DEVELOPMENT ASSESSMENT REPORT	
Application No.	DA/2021/1067
Address	143-149 Norton Street LEICHHARDT NSW 2040
Proposal	Provide an additional storey to a three (3) storey mixed use development with parking approved under Development Application D/2018/427
Date of Lodgement	02 November 2021
Applicant	Xinvest Pty Ltd
Owner	HMMA Properties Pty Ltd
Number of Submissions	Initial: 2 (one objection, one in support)
Value of works	\$534,074.00
Reason for determination at Planning Panel	SEPP 65 (4 storeys or above)
Main Issues	<ul style="list-style-type: none"> • Incompatibility with the streetscape and inconsistent with desired future character controls • Adverse height, bulk and scale impacts to the east-adjointing properties • Non-compliance with Clause 4.4, 4.4A and 6.11A of Leichhardt LEP 2013 • Inadequate separation to the eastern boundary as required in the Apartment Design Guide • Inadequate information - updated Geotechnical and Structural Engineering report not provided

Recommendation	Refusal
Attachment A	Reasons for Refusal
Attachment B	Draft conditions of consent (in the event the Panel resolves to approve the application)
Attachment C	Plans of proposed development
Attachment D

APPROVED DA (D2/018/427)
VIEW FROM MID-POINT AT THE CORNER OF SHORT STREET AND LANEWAY

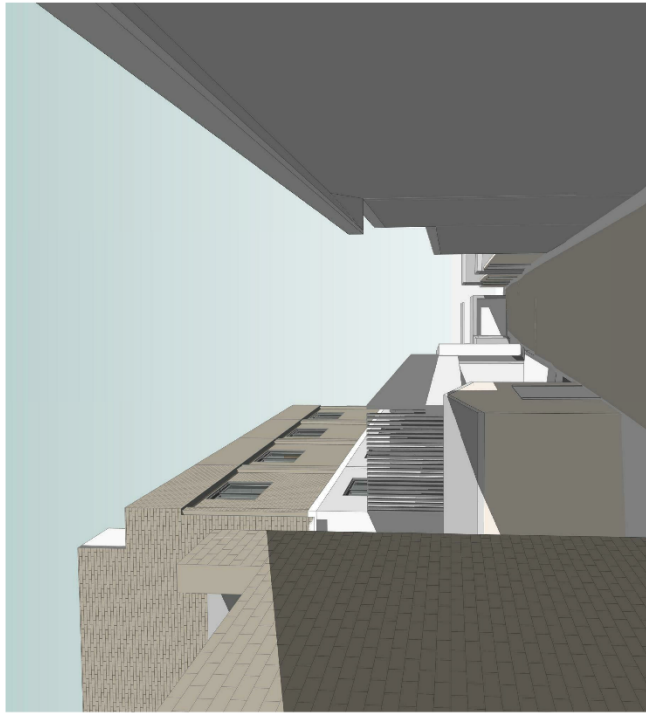
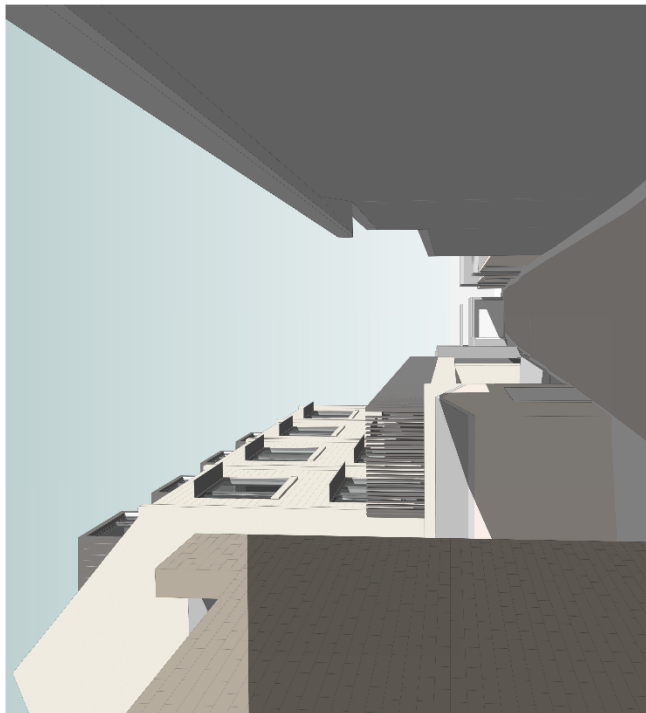
The properties on the northern side of Short Street directly to the east of the proposed site are low density residential housing that predominately have a single-storey presentation to Short Street. The additional fourth level will be clearly visible from Short Street and a four-storey built form will introduce an overwhelming bulk and scale that does not provide an appropriate transition to the low-scale built forms Short Street streetscape on the northern side. The additional fourth level will also result in a development that will be inconsistent with the predominant forms, heights and scales characteristic of this part of Norton Street.

Comment: The roof form of the Level 3 addition to Units 5, 6, 7 and 8 have to the rear of the site have been retained to a gable roof form to the east elevation, with a skillion dormer to each unit and a skillion roof to the west. The revised proposal is 809mm higher than the previous proposal. It will present as 4 storeys to the laneway (approved as 3 storeys as part of D/2018/427).
